CLIENT:
 NORTH QUEENSLAND LOADING AGENTS

PROJECT:
 PROPOSED NEW WAREHOUSE

LOCATION:
 5-13 HARTLEY STREET GARBUTT

DRAWING NO: GMD 6177/1

GROUND FLOOR PLAN
Scale: 1:200

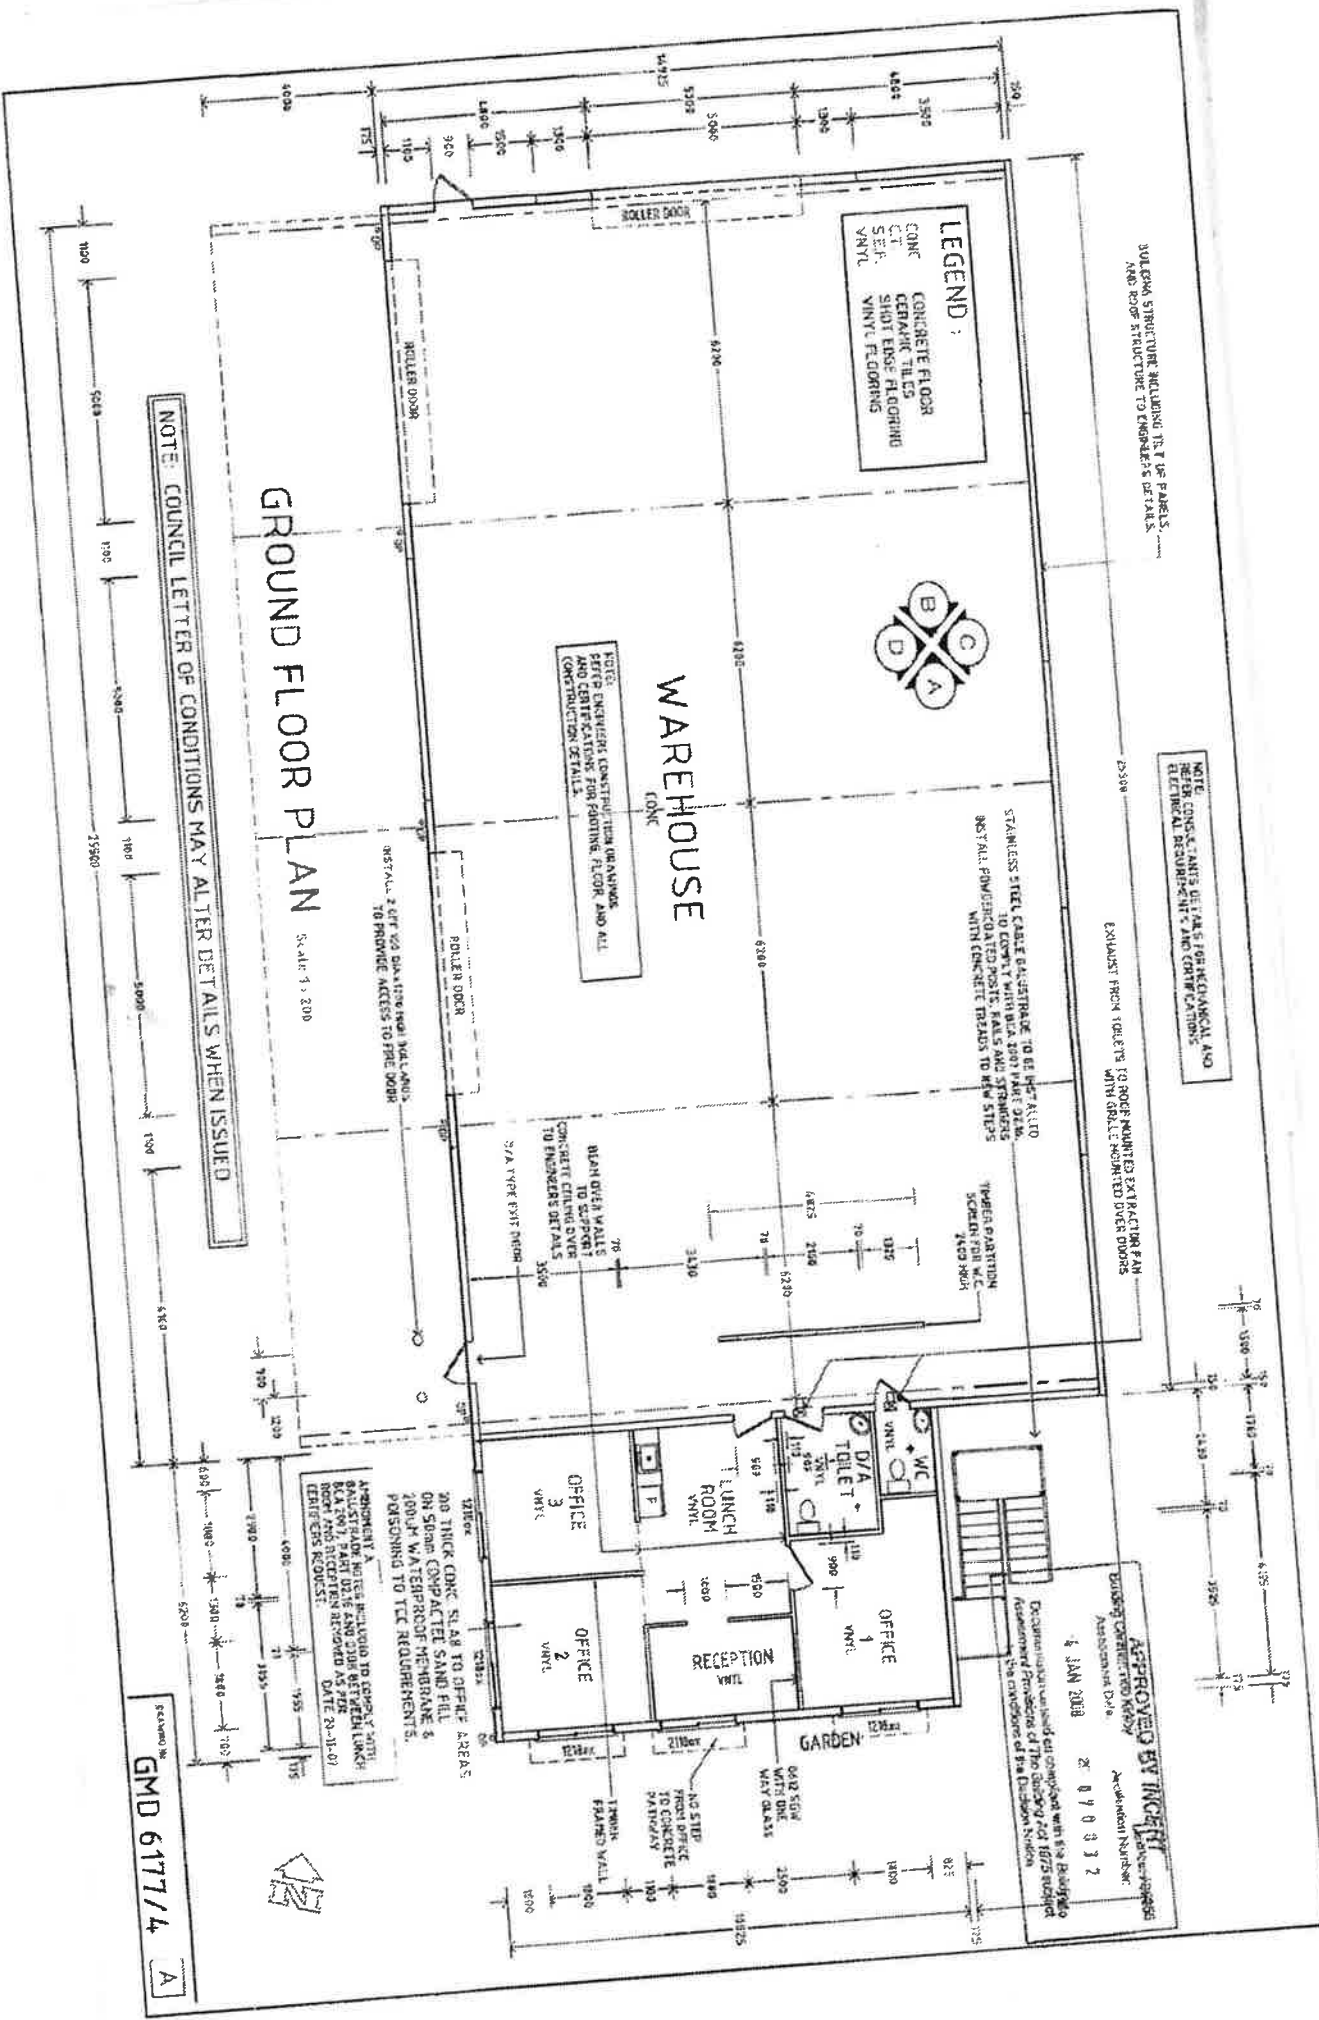
AGREEMENT A
TO STRIKE NOTES IN CONCORD TO GENERAL NOTE
RE: 200MM FILL DRAIN SAND AND WATERPROOF
ROOM AND ROOFING MEMBRANE AS PER
ENGINEER'S REQUEST. DATE 23-11-07

FIRST FLOOR PLAN

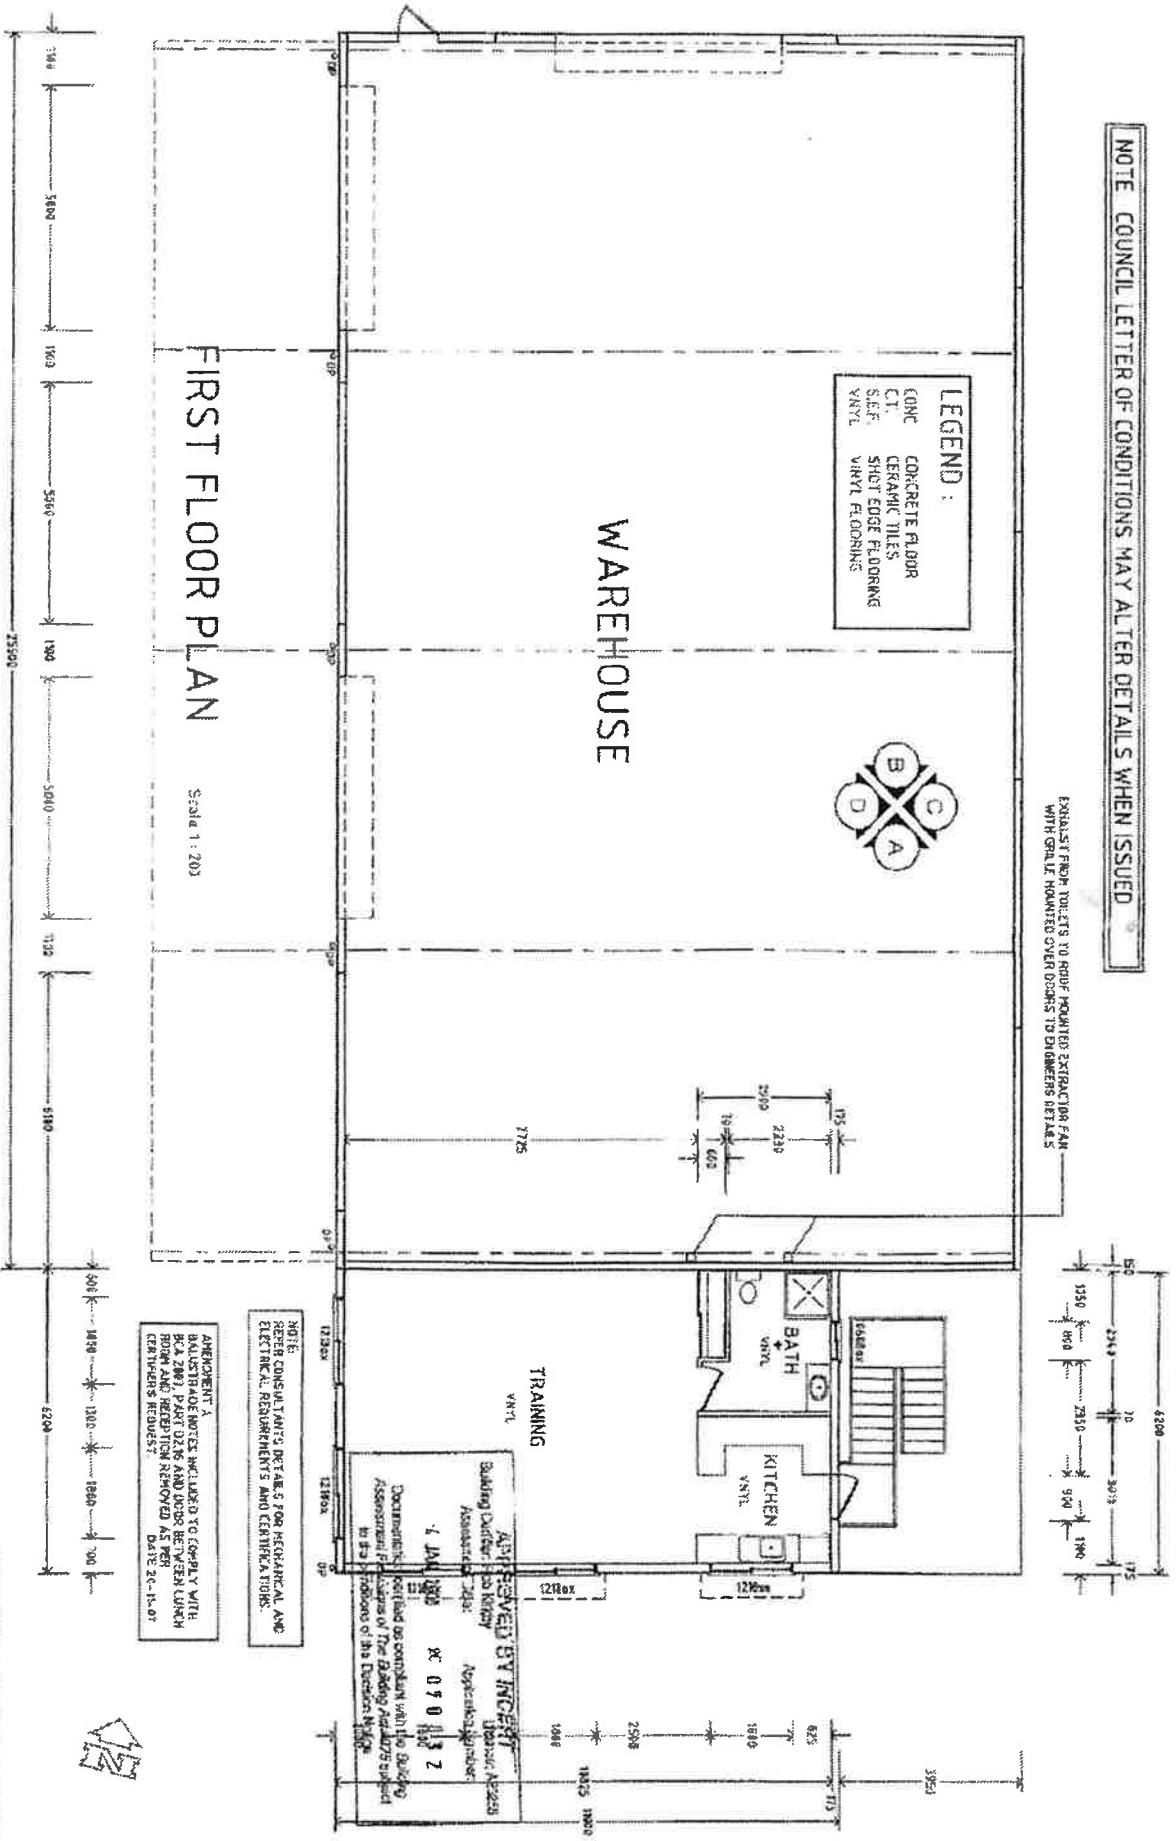
AMENDMENT 1
 BALUSTRADES, BATHS, INCLUDE TO COMPLY WITH BCA 2003 PART 32.6 AND ALSO BETWEEN LURCH ROOM AND RECEPTION REMOVED AS PER CLIENTS REQUEST
 DATE 20-11-07
